J2024-0040
PSP2024-0005
Original Submission
Received 3/4/24

SITE PLAN DRAWING PACKAGE FOR "GERALD PLAZA" AT: 1760 EAST AUBURN ROAD ROCHESTER HILLS, MI 48307 PIN #: 70-15-30-226-068

Site Plan Review
Reviewed for compliance with City Ordinance, Building and Fire Codes
Conditions and mark-ups noted throughout plan set must be addressed prior to final approval

TOPOGRAPHICAL SURVEY

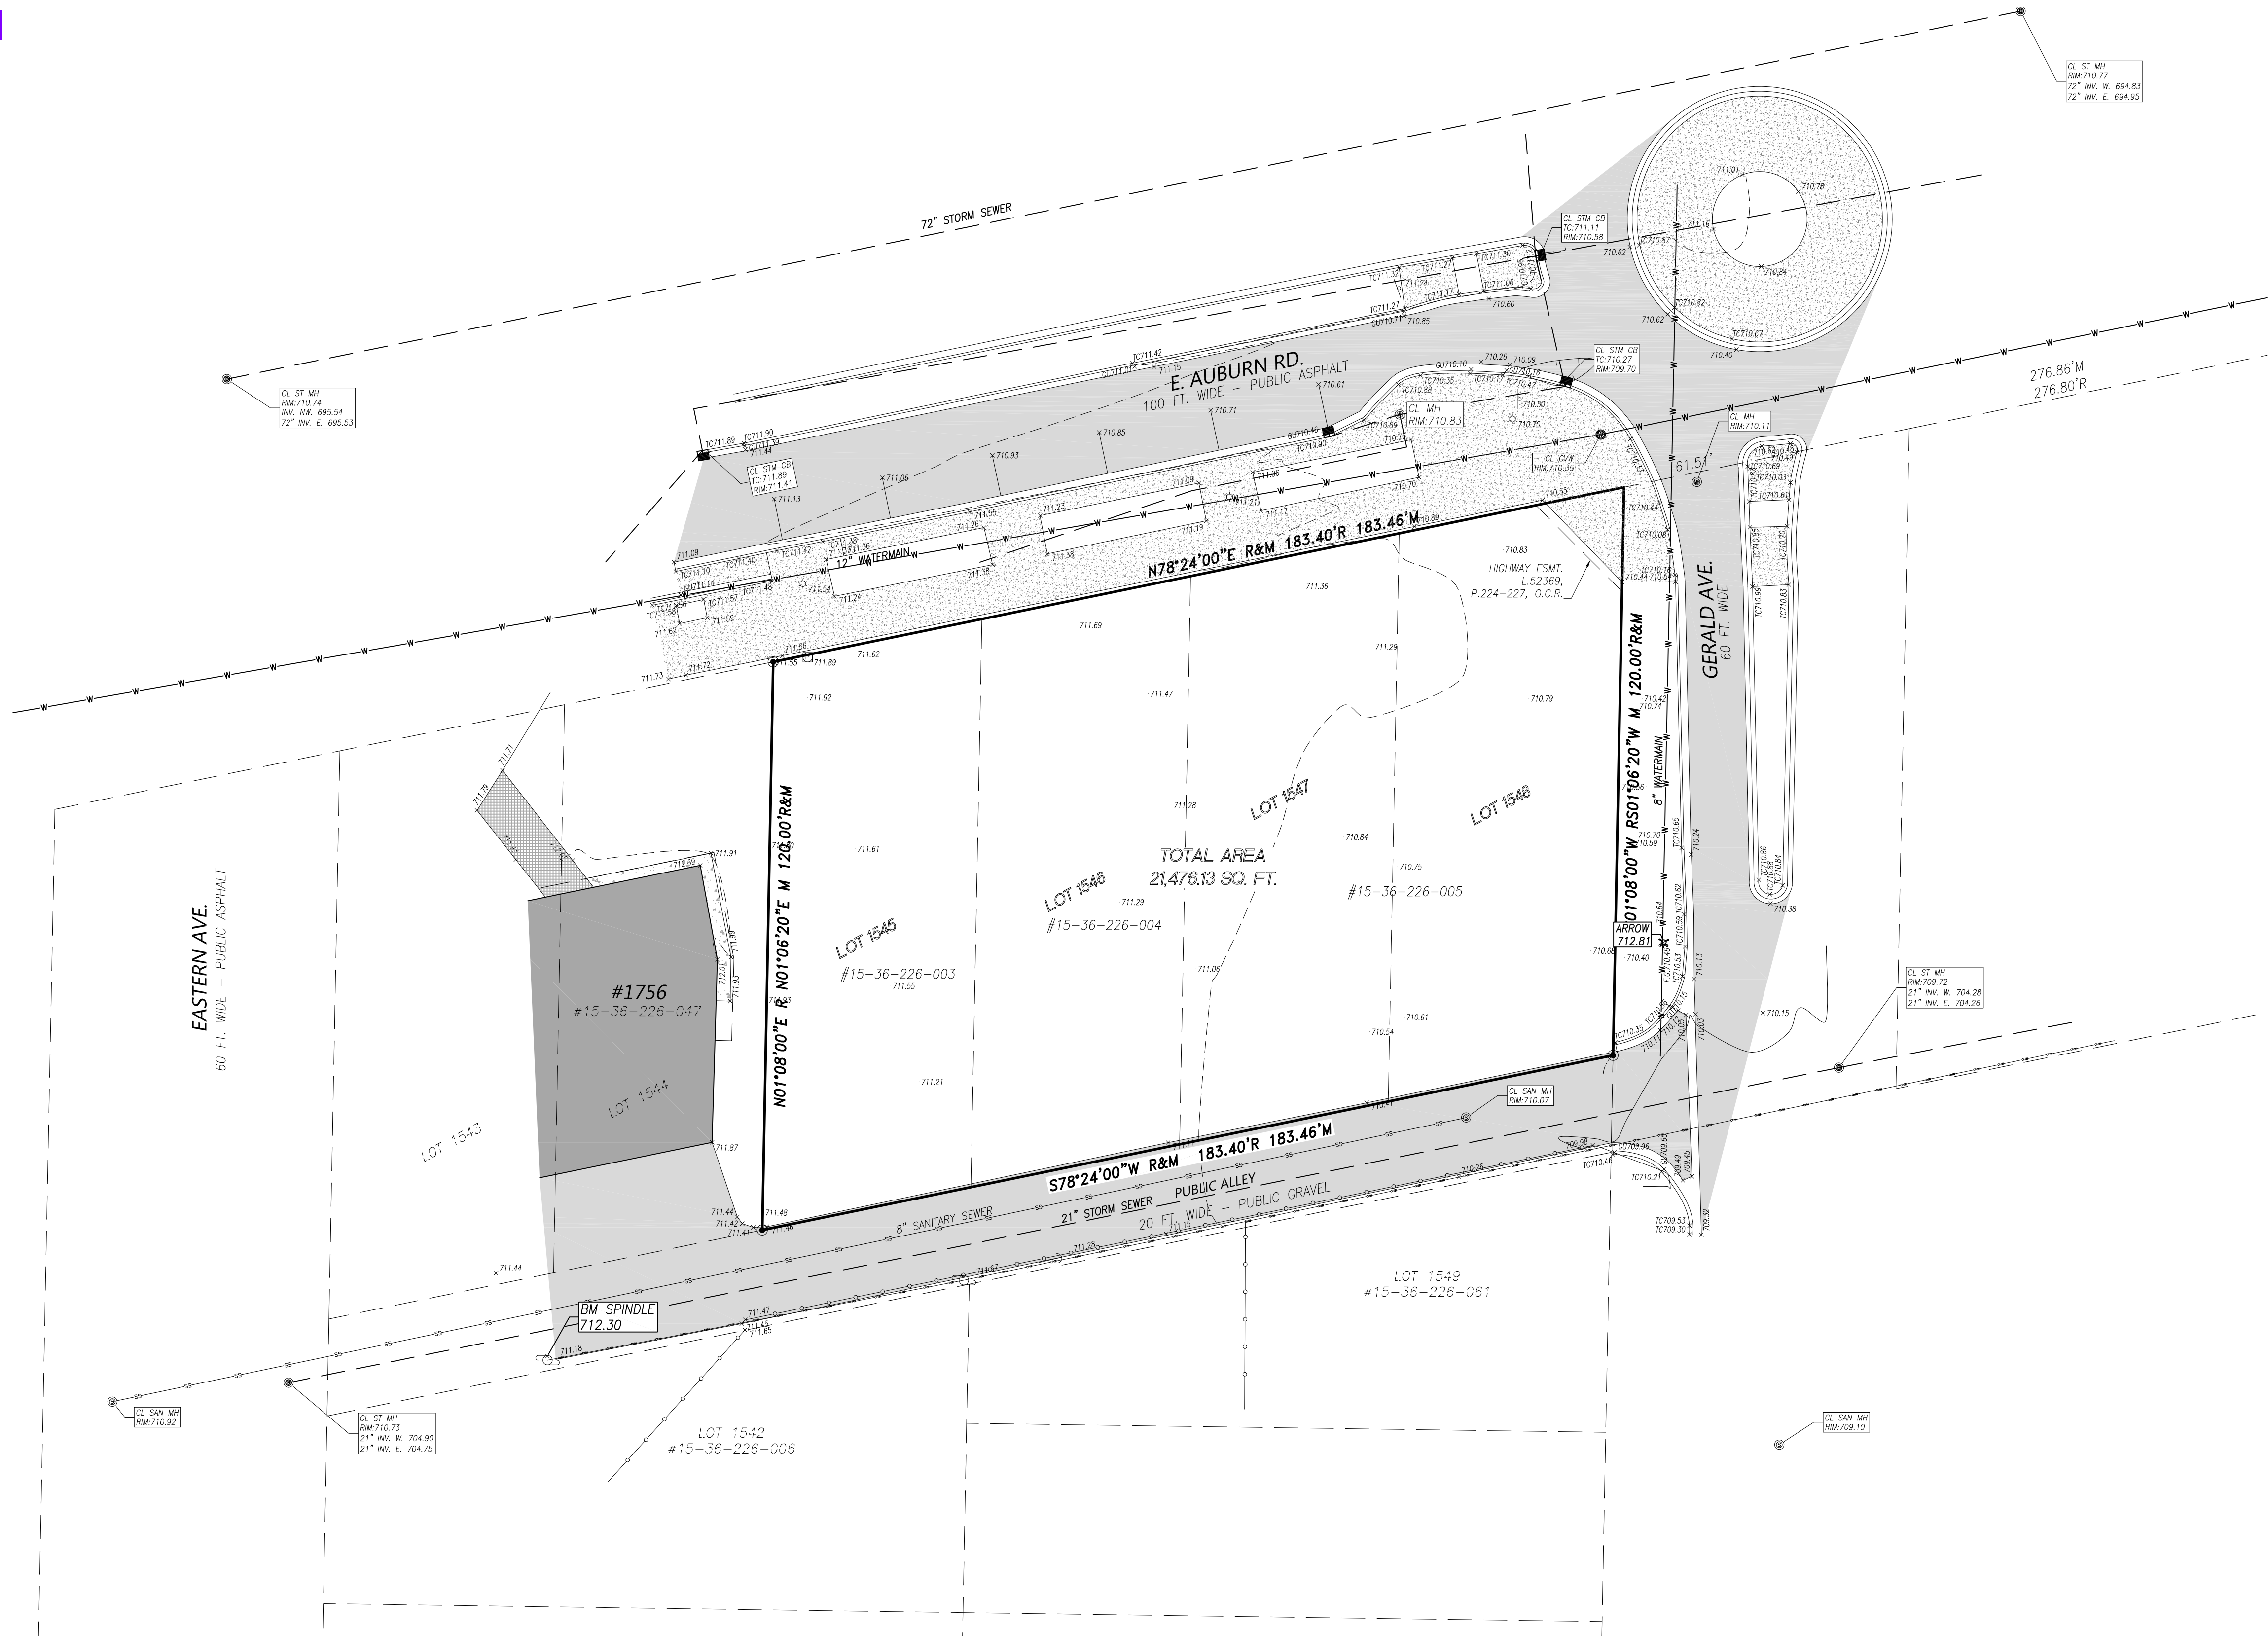
Include current Parcel ID: 15-36-226-008

PROPOSED SITE PLAN SP-02

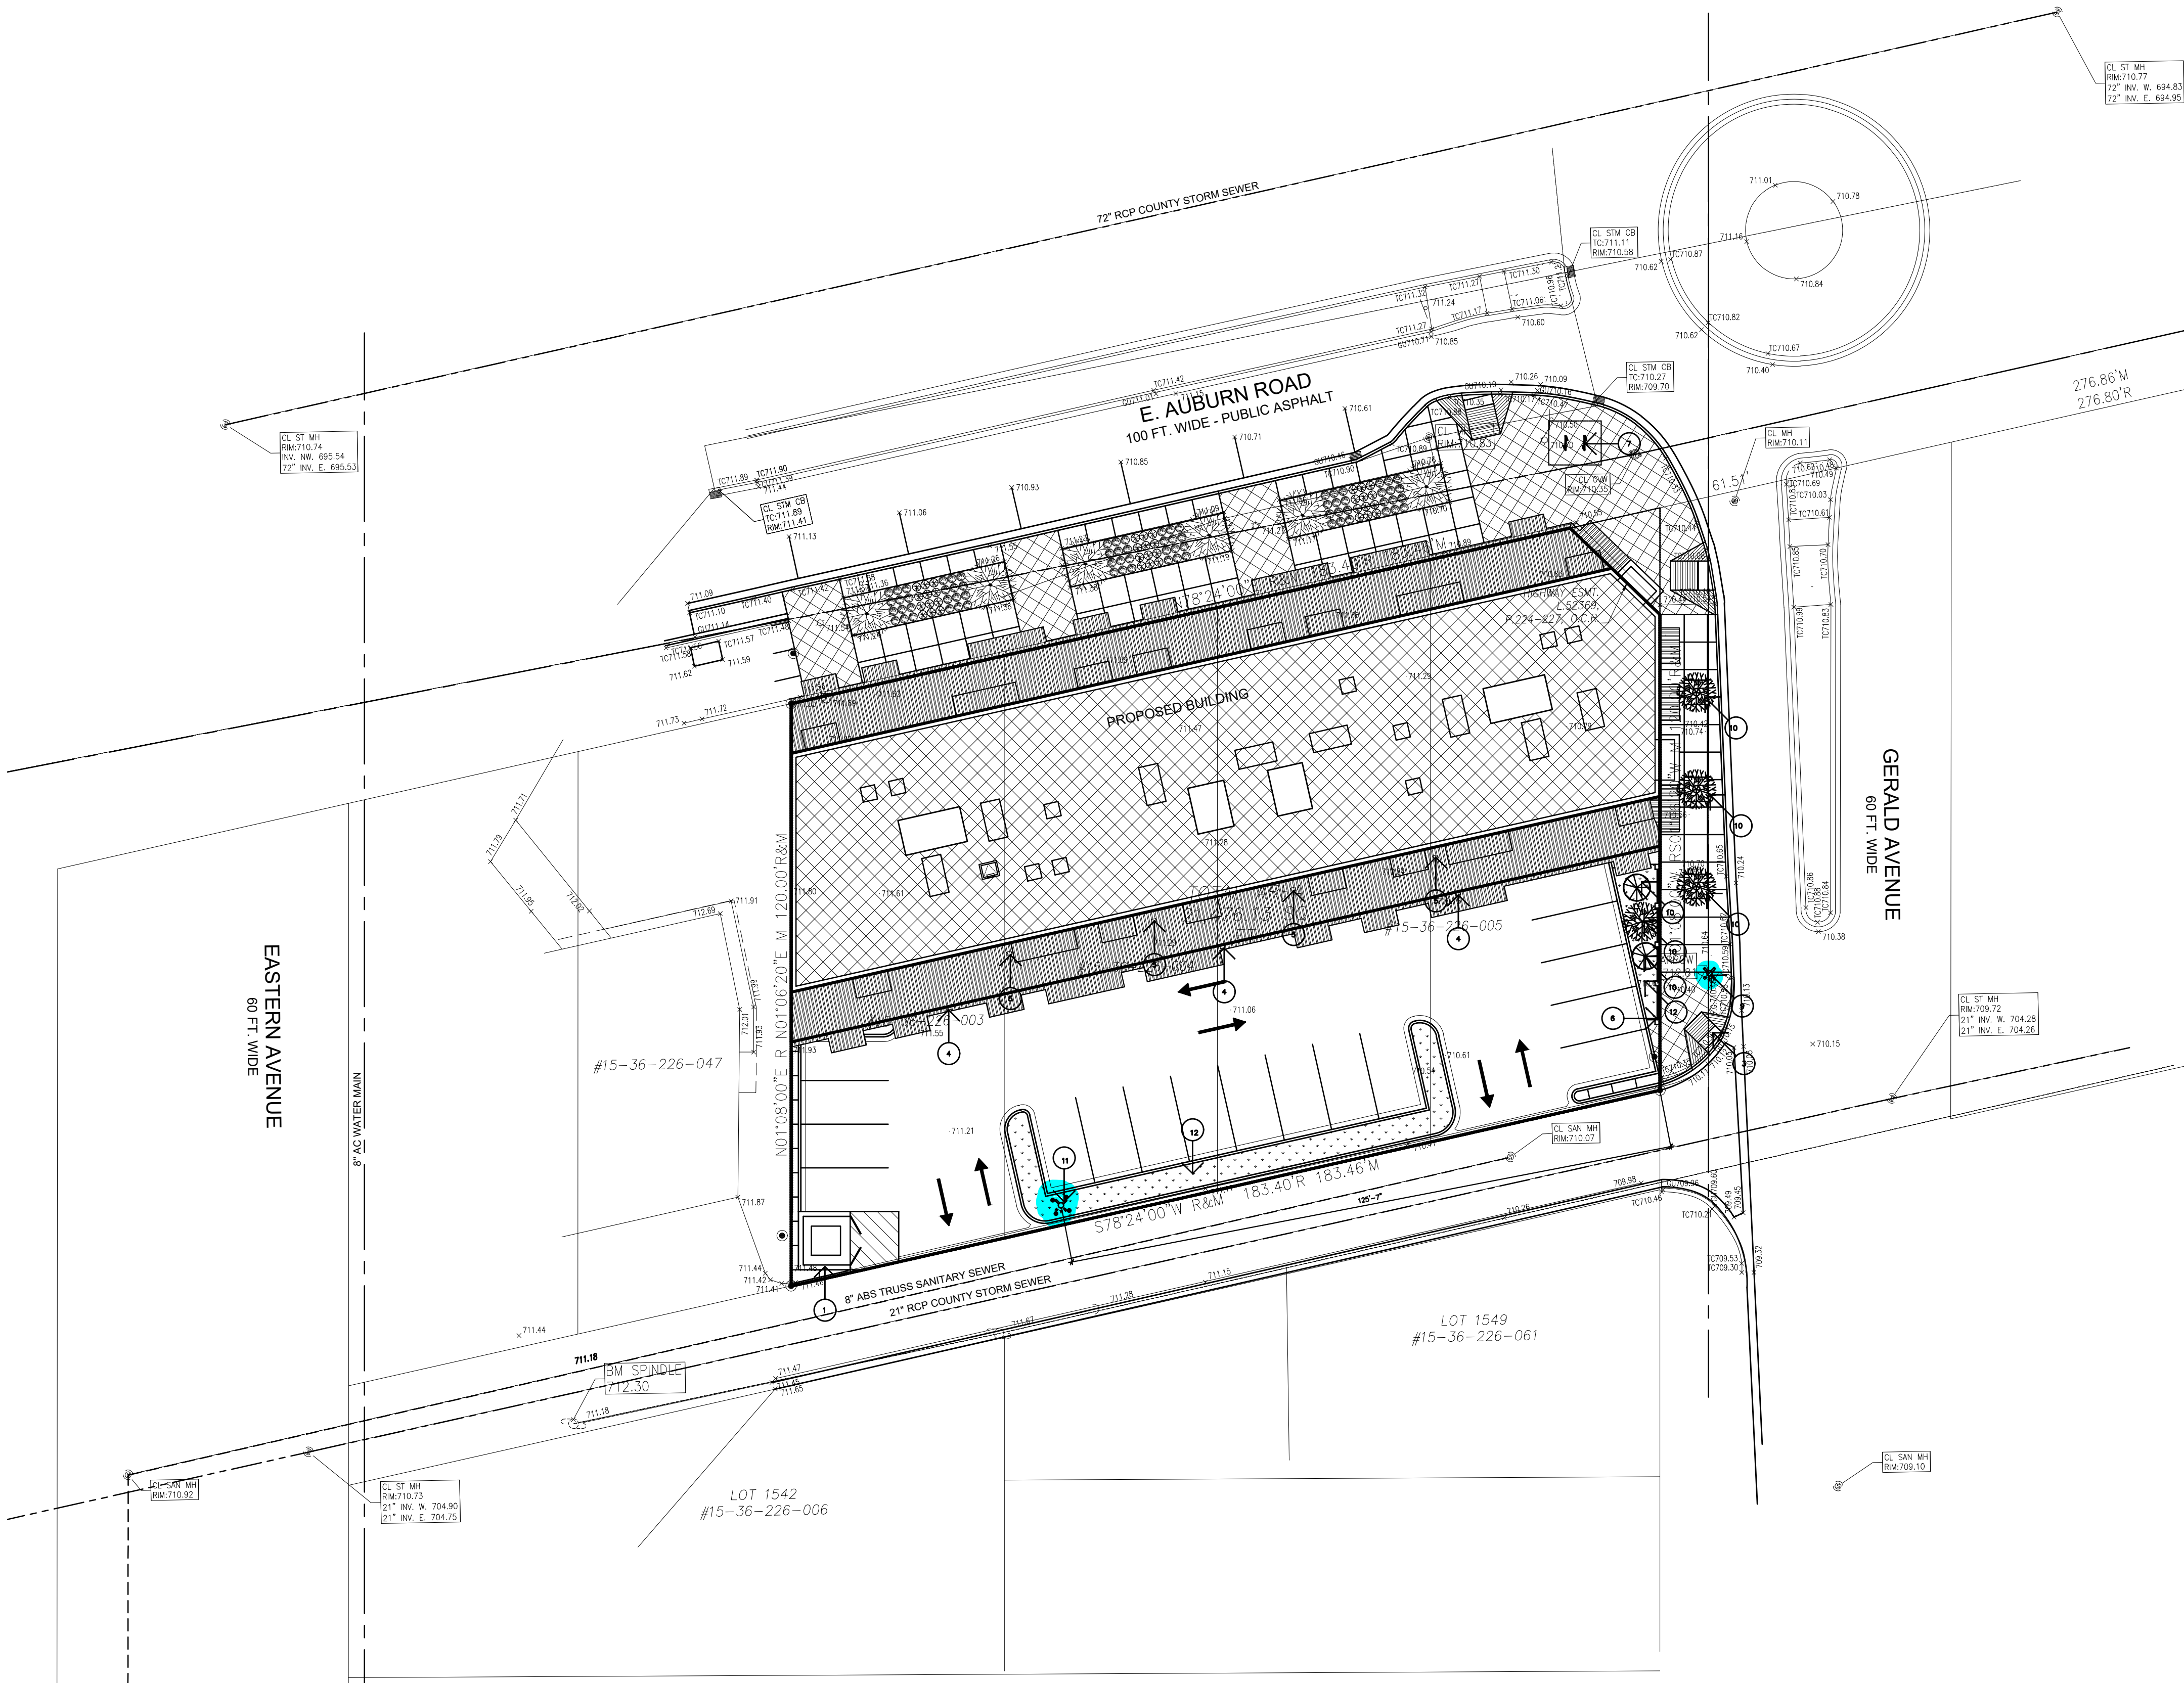
Provide an additional hydrant on the north east corner of the site.

In order to gain site plan approval a flow test is required to evaluate the capabilities of the water supply. The previous flow test is more than a year old and will need to be redone.

UTILITY & GEOMETRY PLAN

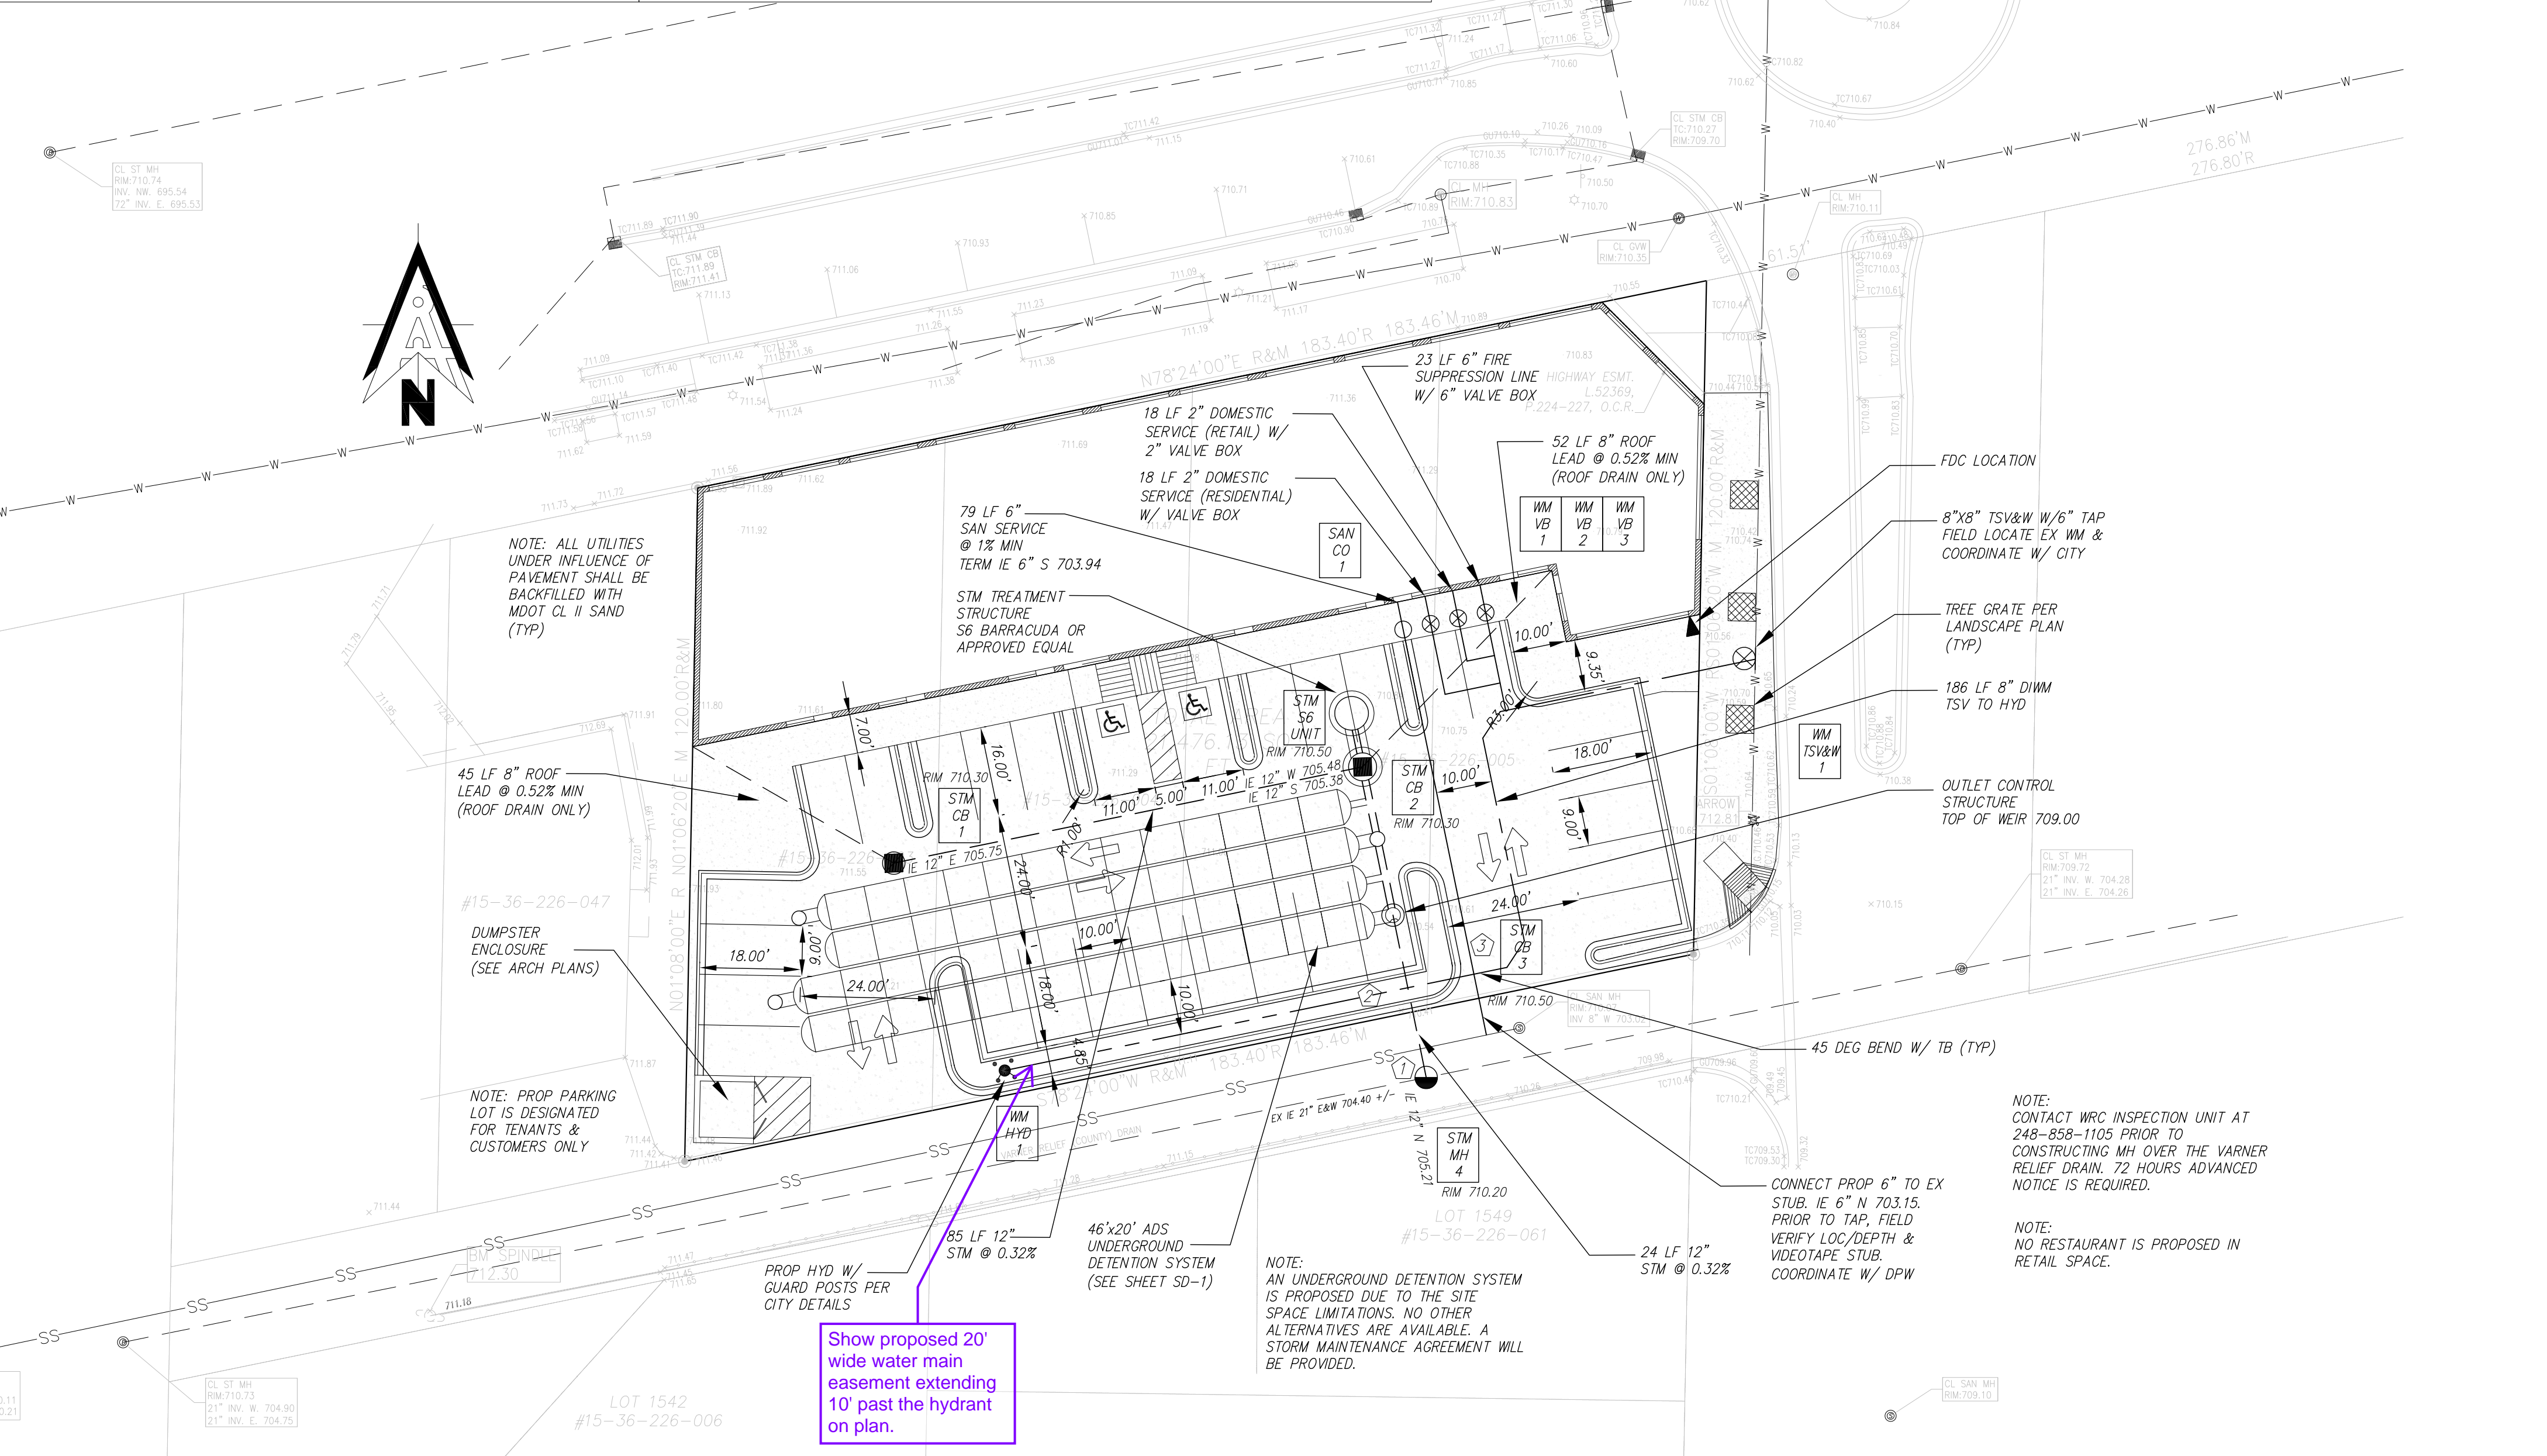
Storm sewer maintenance agreement and water main easement will be needed during construction plan review.
